TECHNICAL REQUIREMENTS MANUAL REVISION 16

ARKANSAS NUCLEAR ONE, UNIT NO. 2

Replace the following pages of the associated Technical Requirements Manual with the attached pages.

TRM Figure 3.9.3-1

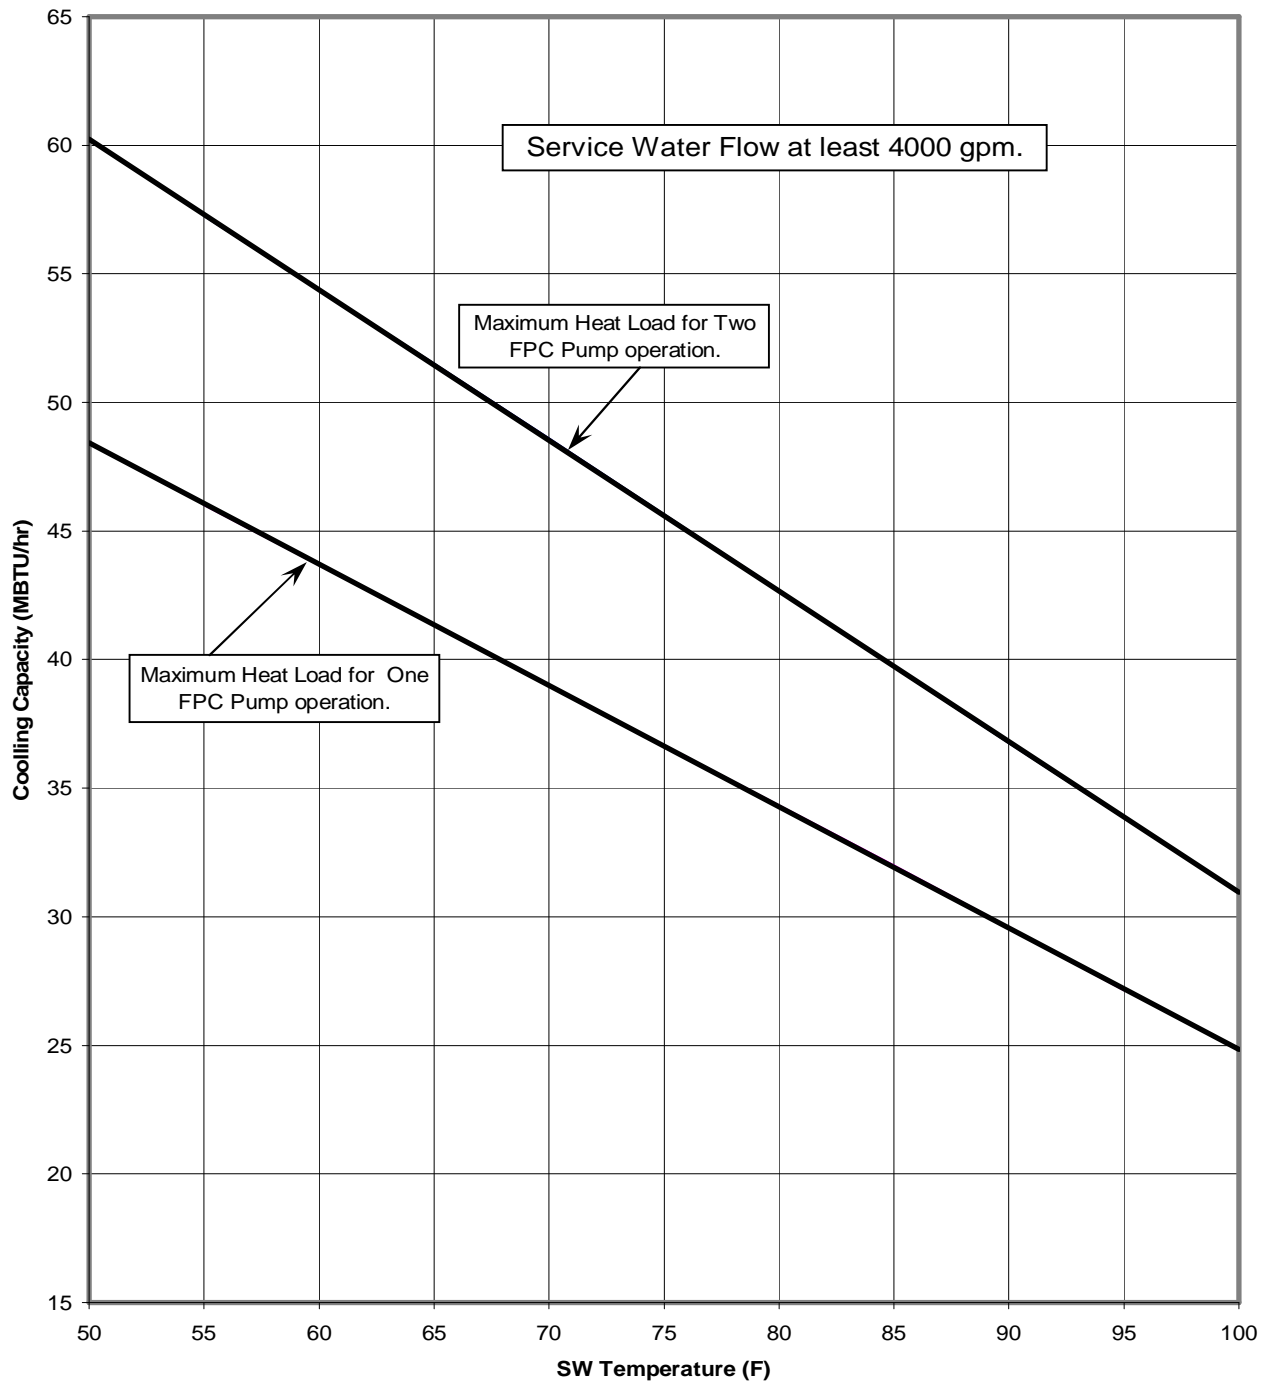
3.9.3 The total heat load in the SFP shall remain within the limits specified in TRM Figure 3.9.3-1 or Figure 3.9.3-2, as appropriate. |

With the total heat load exceeding the requirements in TRM Figure 3.9.3-1 or Figure 3.9.3-2, as appropriate, or with no SFP cooling pump in operation, suspend all transfer of irradiated fuel to the SFP until the limits are restored. |

TRM Figures 3.9.3-1 and 3.9.3-2 depict the cooling capacity limits for the spent fuel pool based upon these parameters. The curves on Figure 3.9.3-1 are based on a total service water flowrate through the SFP heat exchanger of at least 4000 gpm. The curves on Figure 3.9.3-2 are based on a total service water flowrate through the SFP heat exchanger of at least 1600 gpm. Each figure has two curves based on the operation of either one or two Fuel Pool Cooling pumps. The curves are based on not exceeding a Spent Fuel Pool temperature of 150°F during core offload.
